187th session

Pending proposals for amendments to existing UN Regulations submitted by GRE and GRSG

Proposal for Supplement 1 to the 08 series of amendments to UN Regulation No. 48 (Installation of lighting and light-signalling devices)

Submitted by the Working Party on Lighting and Light-Signalling*

Annex 1, item 9.22., amend to read:

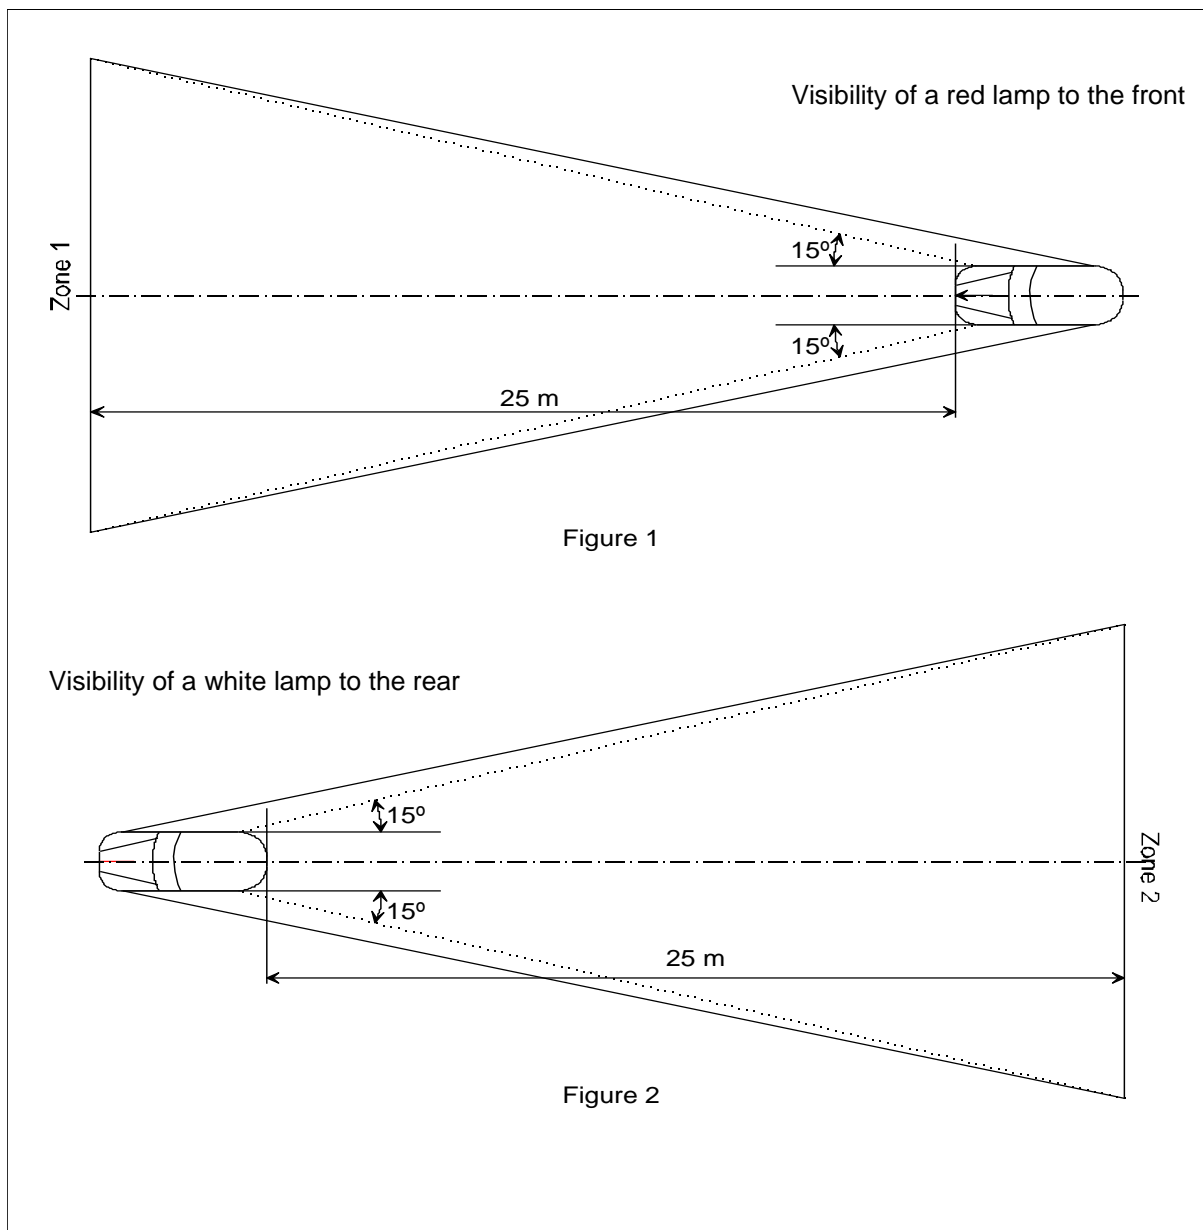
"9.22.	Adaptive front lighting system (AFS):	yes/no ²
9.22.1.	Main-beam ADB	yes/no ²
9.22.1.1.	Main-beam ADB + Driver Assistance Projection	yes/no ² "

“Annex 4

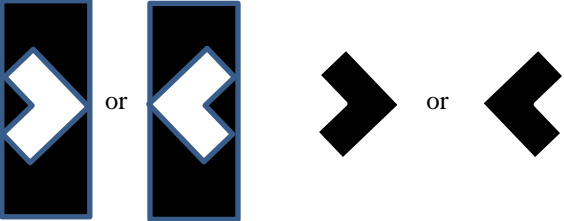
Visibility of a red lamp to the front and visibility of a white lamp to the rear

In their respective planes, the zones 1 and 2 explored by the eye of the observer are bounded:

- In height, by two horizontal planes 1 m and 2.2 m respectively above the ground;
- In width, by two vertical planes which, forming to the front and to the rear respectively an angle of 15° outwards from the vehicle's median longitudinal plane, pass through the point or points of contact of vertical planes parallel to the vehicle's median longitudinal plane delimiting the vehicle's overall width; if there are several points of contact, the foremost shall correspond to the forward plane and the rearmost to the rearward plane.”
